### Office Action Summary

10/765,391

## **DETAILED ACTION**

**FIG. 5**

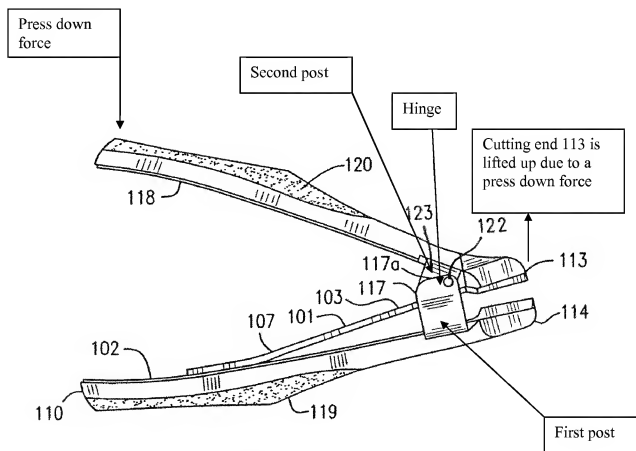
2. The disclosure is objected to under 37 CFR 1.71, as failing to describe how the claimed nail clipper functions. It is to be noted that for the purpose of this office action, the Examiner uses the latest Amendments to the Specification and the Drawings filed on 12/15/2008 to explain his position.

It is to be noted that the last sentence in the Amendments to the Specification states “a second post 122 is connected to the post 117 by a hinge 123” while the Amendments to Drawings show the second post being designated by numeral 123 and the hinge being designated by numeral 122. For the discussion, the Examiner assumes that numeral 123 is the second post and numeral 122 is the hinge.

According to the principle of leverage, the first post 117 acts as a fulcrum and the lever 118 pivots about the hinge 122. When the lever 118 is pressed down, the cutting end 113 is lifted up according to the principle of leverage. This is not the intended use of the nail clipper since the press down force is supposed to bring the cutting ends (113, 114) close together to cut a nail.

Applicant is required to submit an amendment which clarifies the disclosure so that the examiner may make a proper comparison of the invention with the prior art. Applicant should be careful not to introduce any new matter into the disclosure (i.e., matter which is not supported by the disclosure as originally filed).

The Applicant argues that the lever 118 and the cutting end 113 are not connected because the connection between the lever 118 and the cutting end 113 is shown as a break line in the reproduced Fig. 5 in the Remark. This argument is not persuasive. The break line may show the change in shape of the lever 118 and the cutting end due to the cutting end being bended to a side but not in front of the clipper. If the lever 118 and the cutting end are not connected as argued by the Applicant, then how can the cutting end 113 be spaced apart from the cutting end 114? Furthermore, the reproduced Fig. 5 does not explain how the lever 118 presses or moves the cutting end 113 toward the cutting end 114.
